# ADDENDUM NO. 1

**April 29, 2022**

**NEW ADMINISTRATION CENTER, ALTERNATE EDUCATION AND  
RESOURCE CENTER AND RELATED WORK PROJECT  
Crown Point, IN 46307**

This Addendum forms a part of and modifies the Bidding Requirements, Contract Forms, Contract Conditions, the Specifications, and the Drawings dated April 15, 2022 by Gibraltar Design. Acknowledge receipt of the Addendum in the space provided on the Bid Form. Failure to do so may subject the Bidder to disqualification.

## MECHANICAL DETAILS & DIAGRAMS

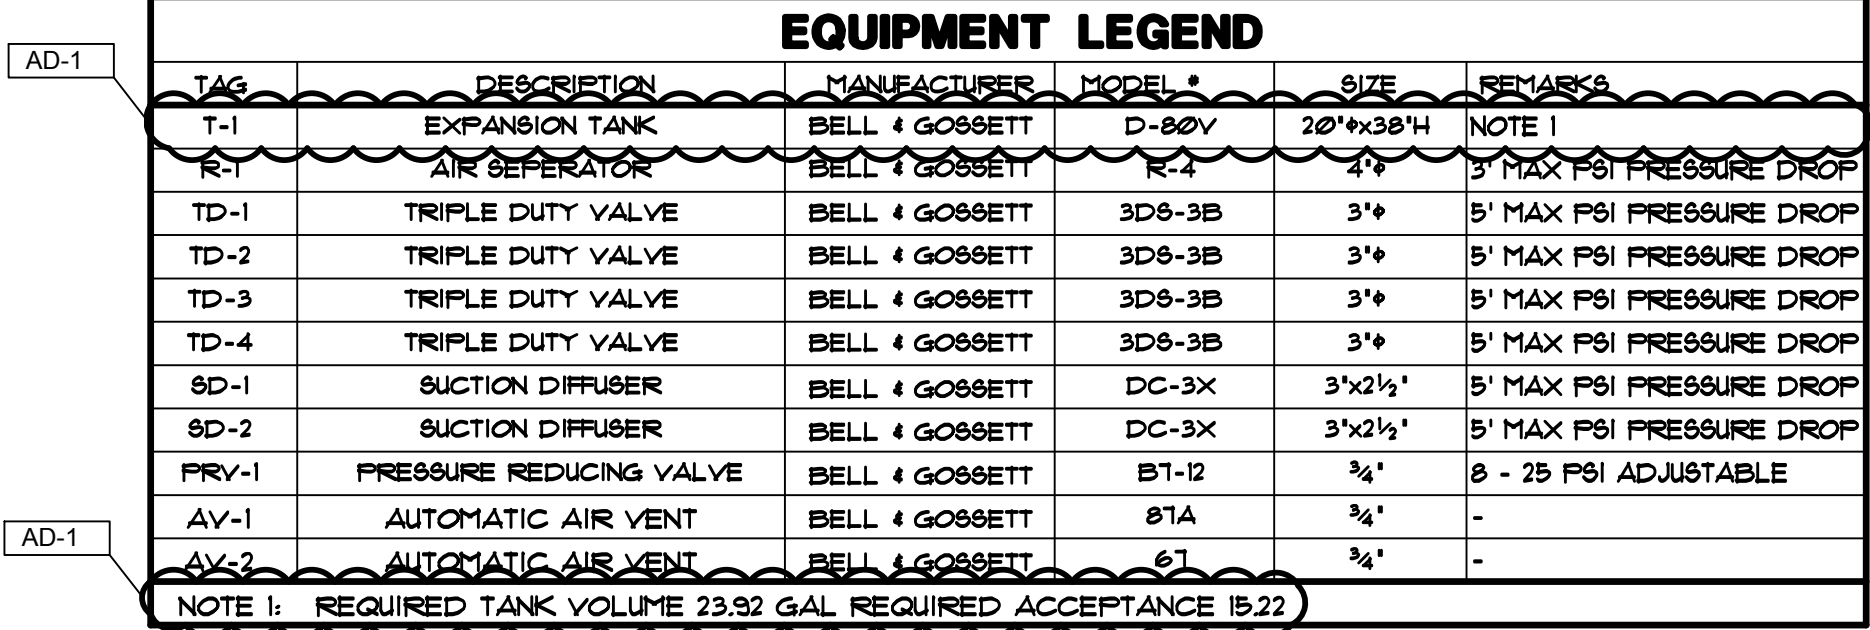
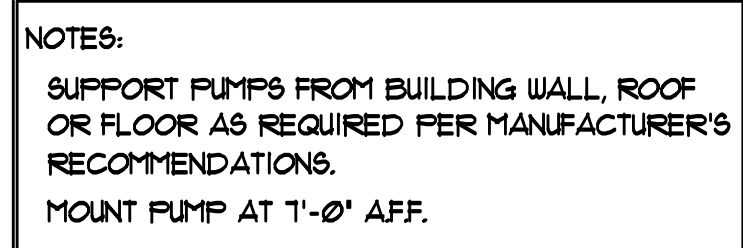
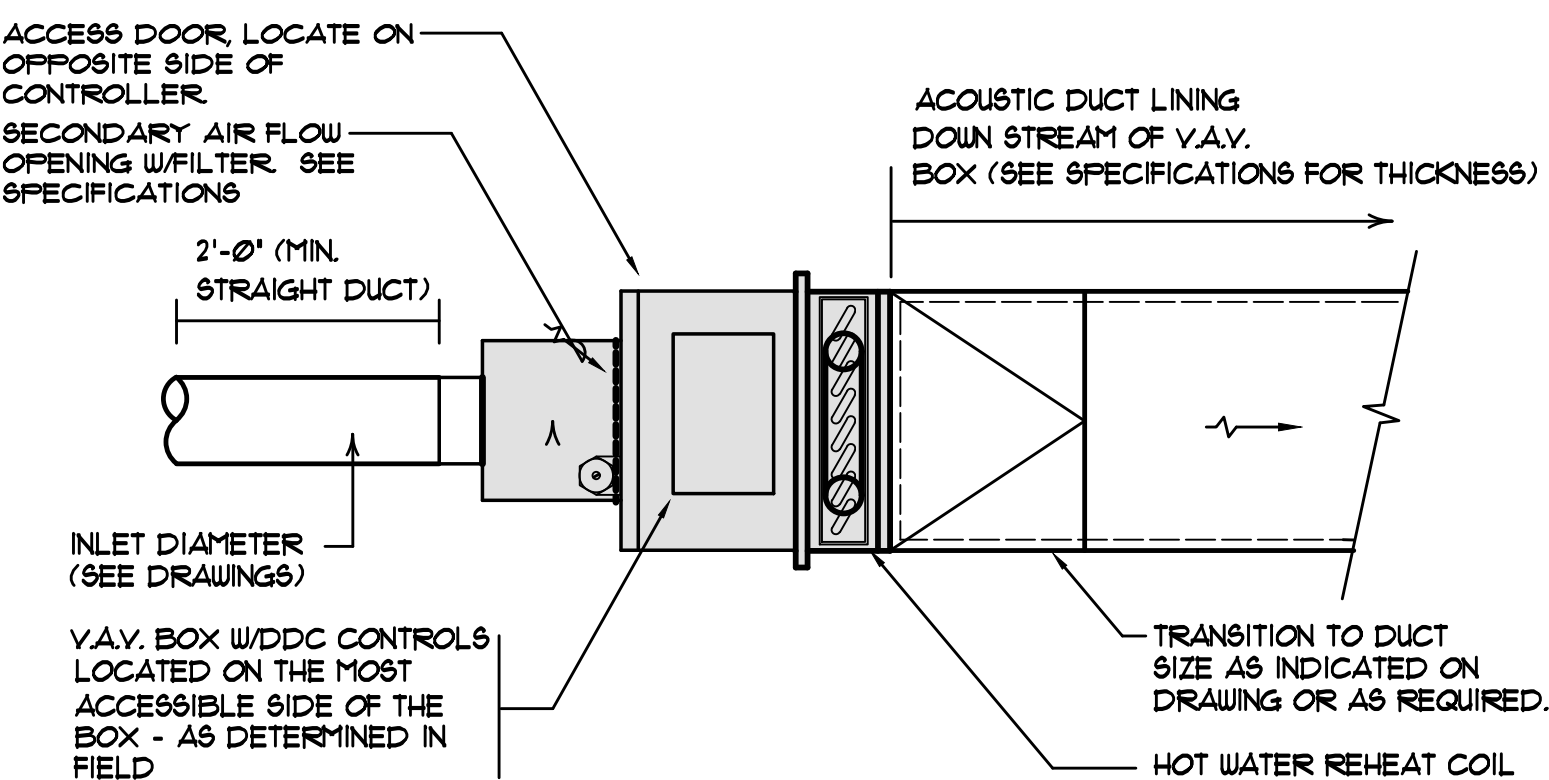
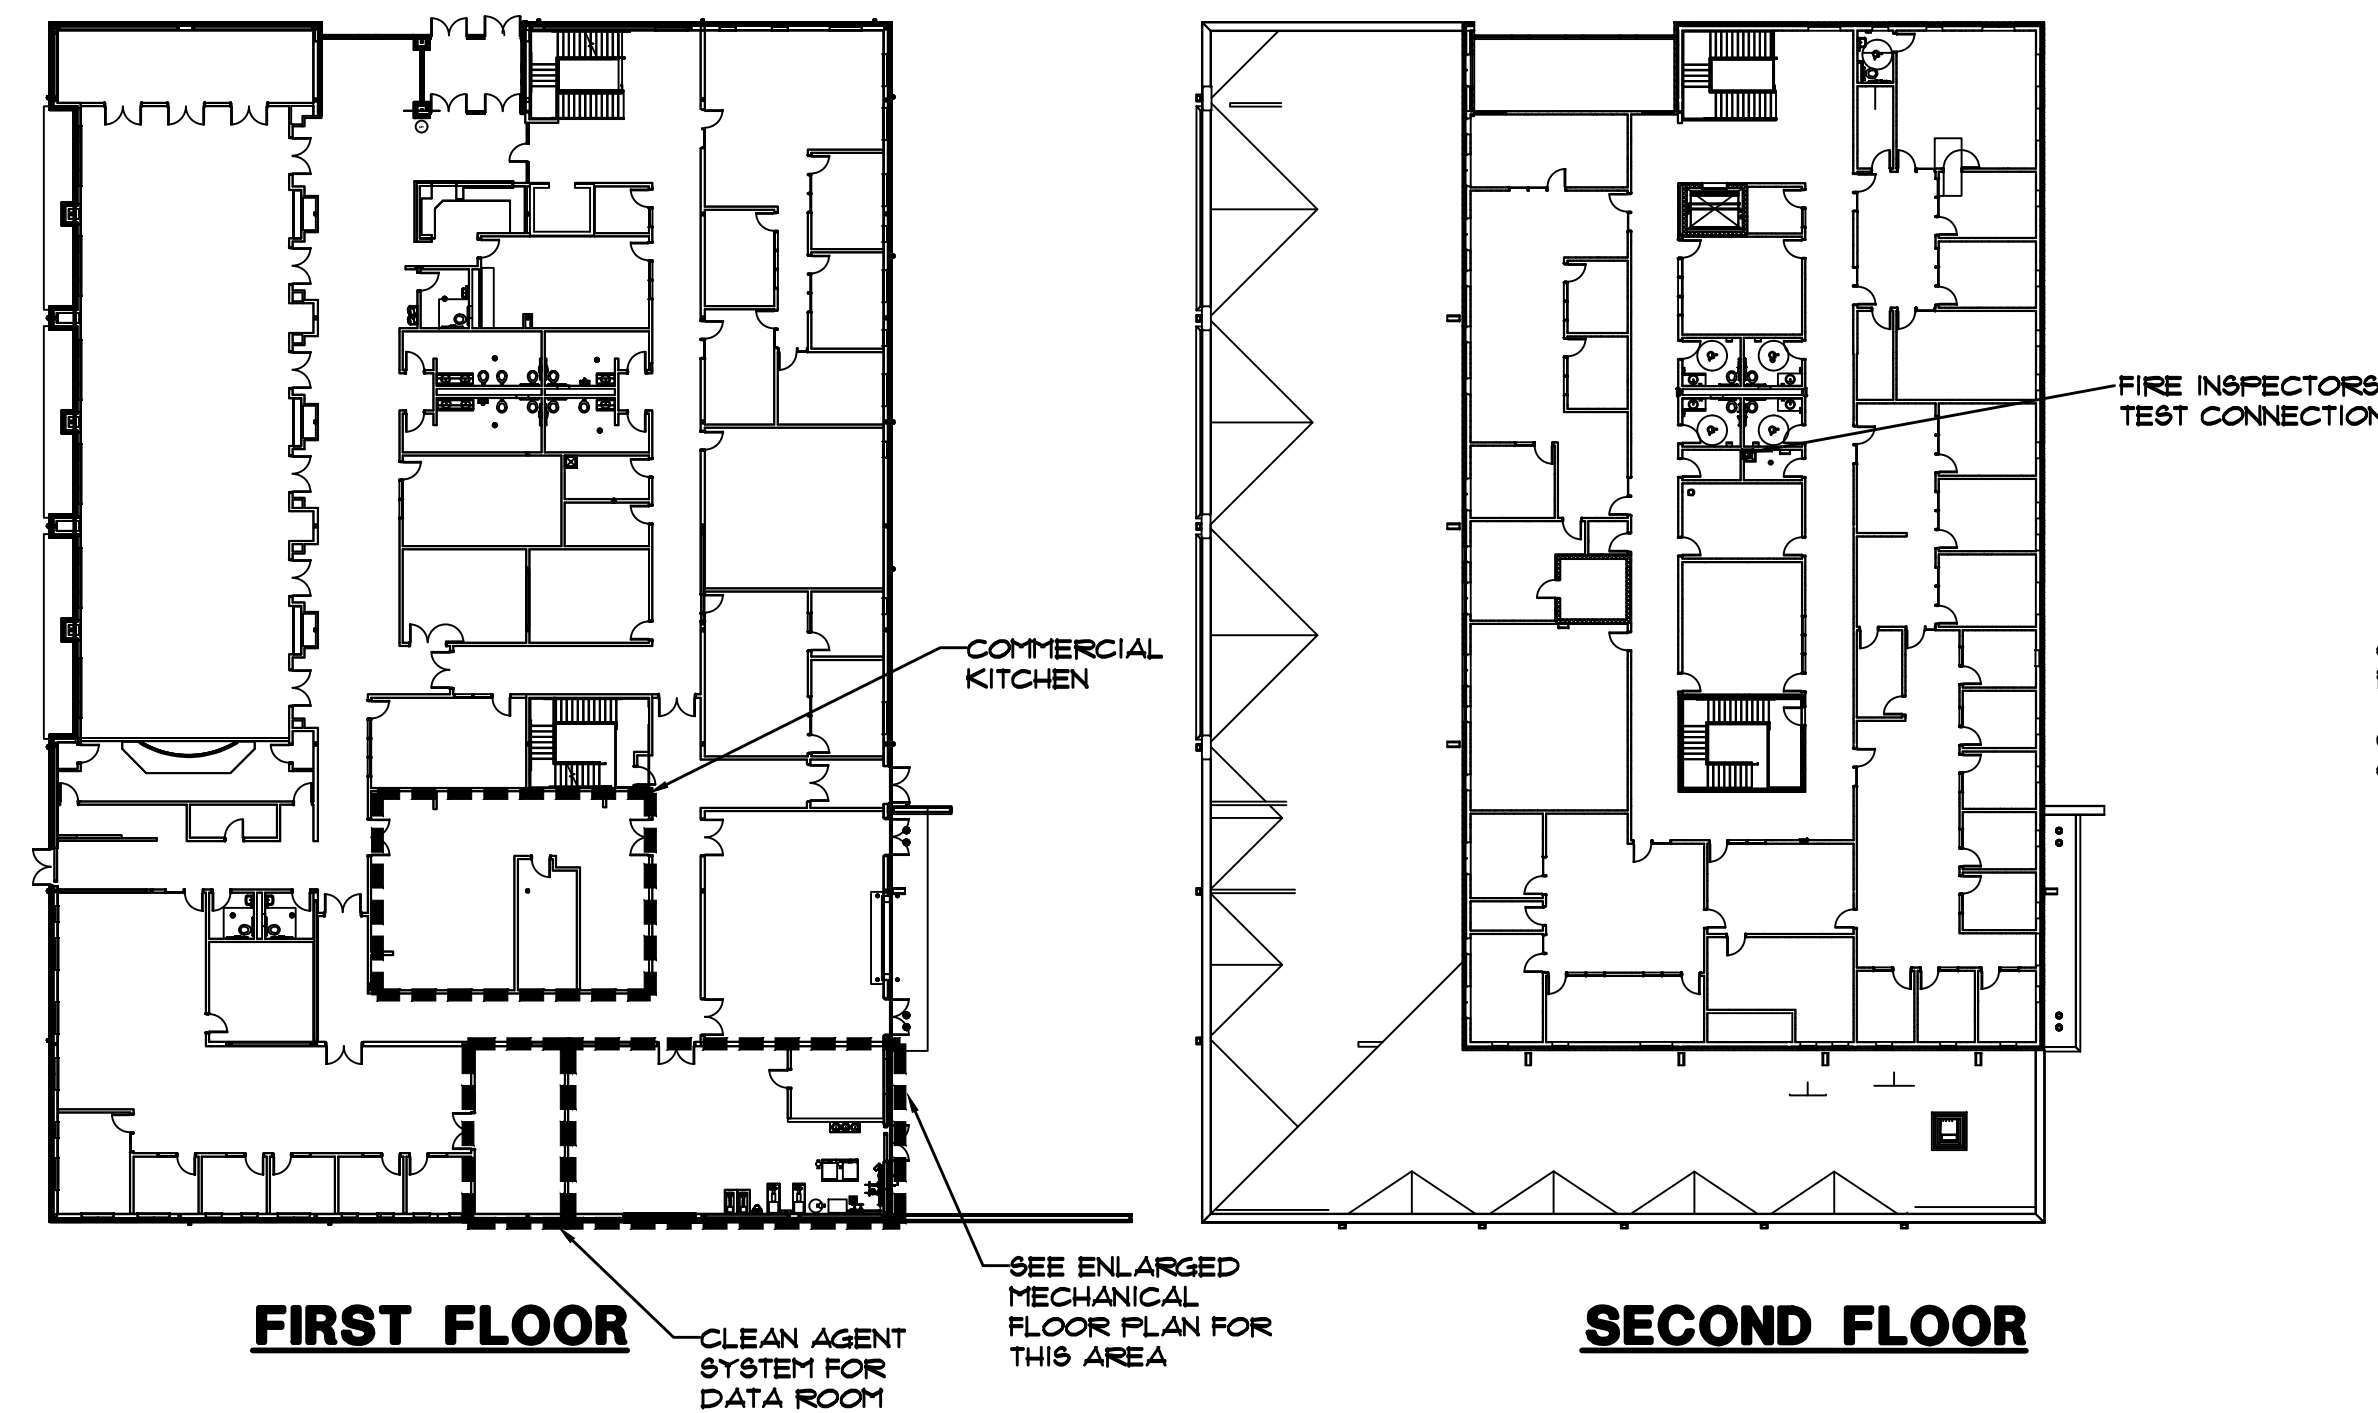
**9. Sheet M-501**

- A. Refer to revised, full size drawing, included in this Addendum, for Updated UH-1 and UH-2 heating data.
